SUPPLEMENT #1 TO ADDENDUM #2
TO THE
TECHNICAL DRAINAGE STUDY
FOR
THE HUNTRIDGE

DS 5769
W.O. # CW-2222
October 1, 2024

**Re: The Huntridge, DS 5769
Supplement #1 to Addendum #2 to the Technical Drainage Study**

Cross Section Cross Section for Irregular Channel

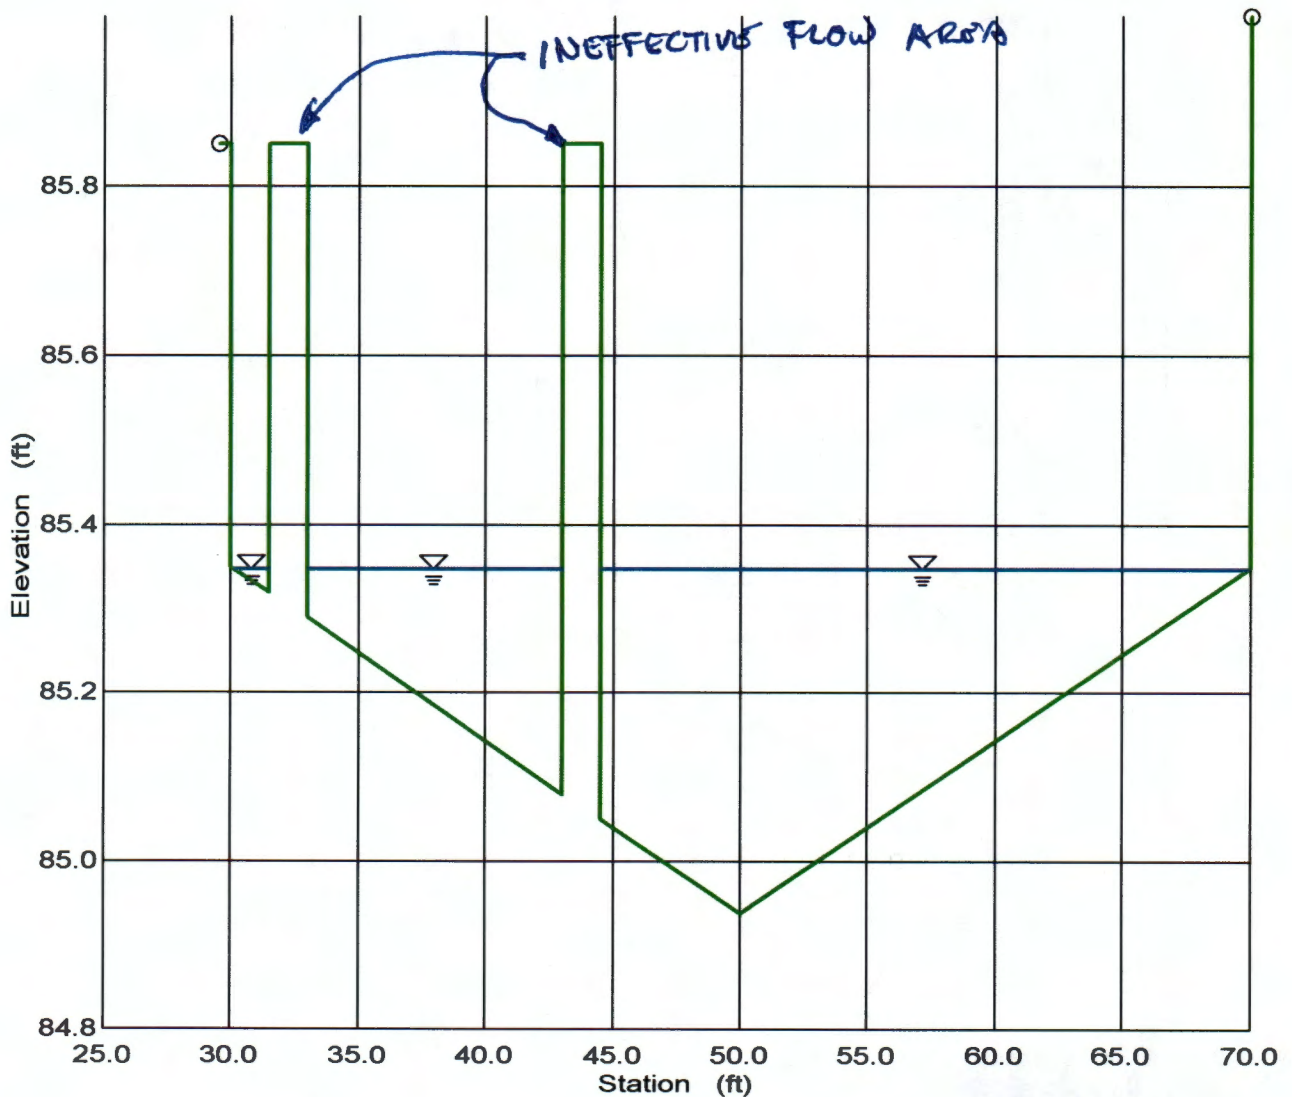
2. The depth of flow calculations was checked along the southside of the proposed buildings, near the entrance of the alley and Maryland Pkwy to find that the existing buildings and proposed additions are not protected to 1.5 feet above the water surface elevation in Maryland Pkwy nor the 0.48 feet above the flow line. We do not see the elevations on the plans matching the hydraulic calculations that show otherwise.

4. The hydraulic calcs are shown in the original submittal but there are no updated calculations to show the revised finish floor elevations or slopes and we do not see updated plans calling out the adjusted design to provide freeboard for the buildings in the Alley. For example, the hydraulic calculations in the drainage study show existing finish floor is 84.85 and another elevation 85.85 but do not see it on the plans.

$85.76 < 85.85$
 \therefore BLDG IS PROTECTED

Results	
Wtd. Mannings Coefficient	0.016
Water Surface Elevation	85.35 ft
Flow Area	7.63 ft ²
Wetted Perimeter	37.40 ft
Top Width	36.75 ft
Height	0.41 ft ← d_{100}
Critical Depth	85.40 ft
Critical Slope	0.006044 ft/ft
Velocity	3.67 ft/s
Velocity Head	0.21 ft
Specific Energy	85.56 ft
Froude Number	1.42
Flow is supercritical.	
Flow is divided.

Cross Section Cross Section for Irregular Channel

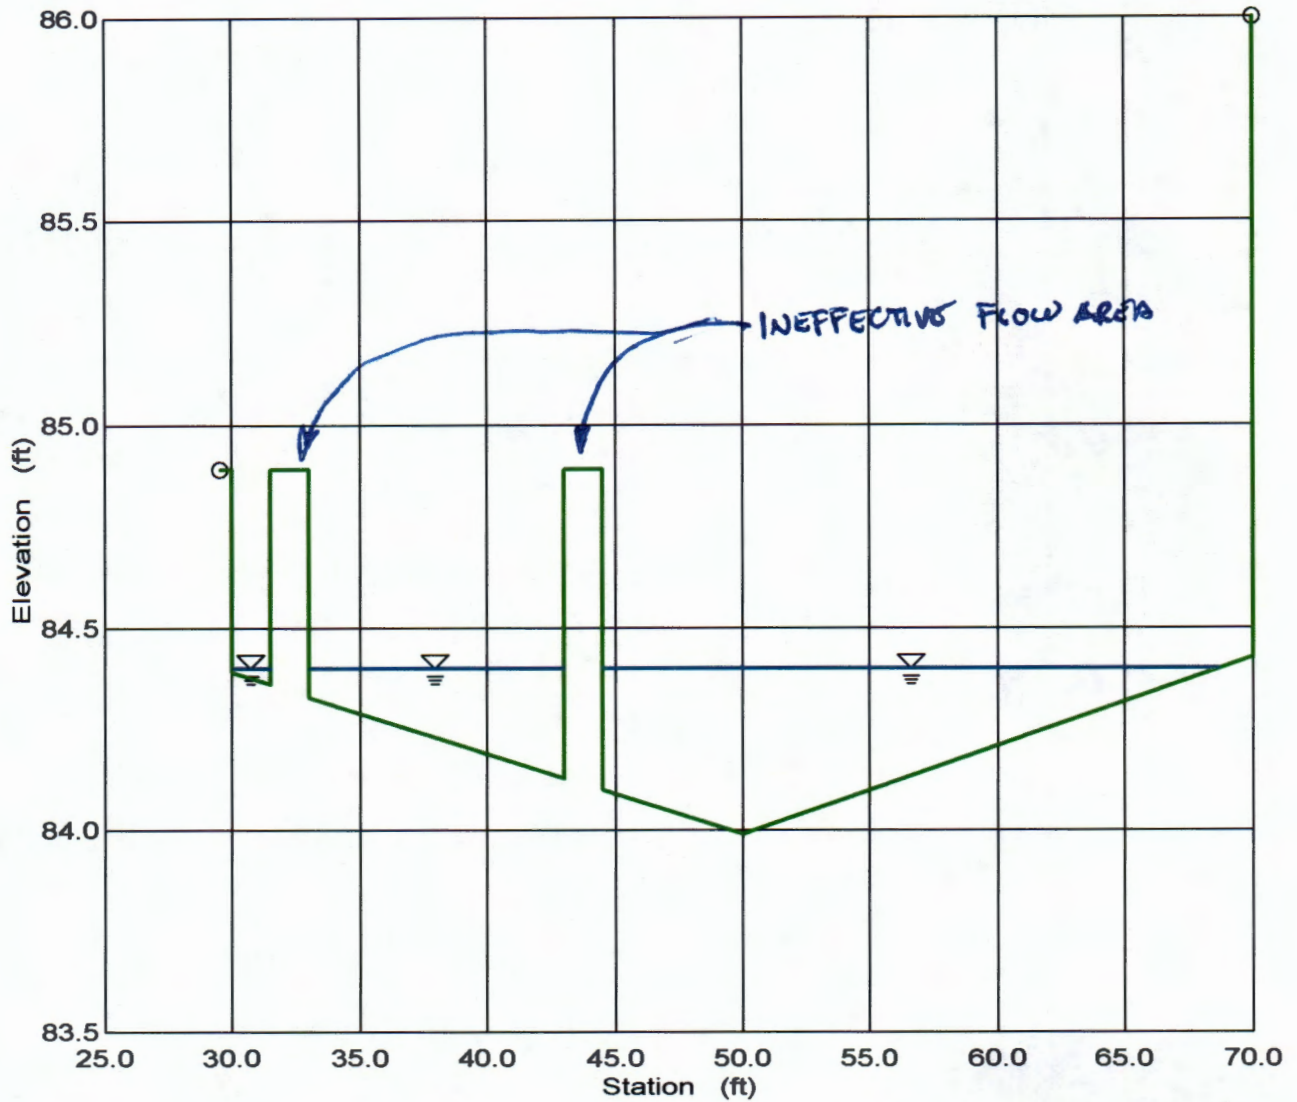
3. The hydraulic calculations are also showing the proposed finished floor elevations not meeting the 2XD, which is also not meeting criteria 903.6 from the Manual; we have concern that the parking stalls are utilized as full conveyance.

$84.81 < 84.89$
 \therefore BLDG IS PROTECTED

Results		
Wtd. Mannings Coefficient	0.016	
Water Surface Elevation	84.40	ft
Flow Area	7.55	ft ²
Wetted Perimeter	36.39	ft
Top Width	35.68	ft
Height	0.41	ft ← d100
Critical Depth	84.46	ft
Critical Slope	0.006052ft/ft	
Velocity	3.71	ft/s
Velocity Head	0.21	ft
Specific Energy	84.61	ft
Froude Number	1.42	
Flow is supercritical.		
Flow is divided.
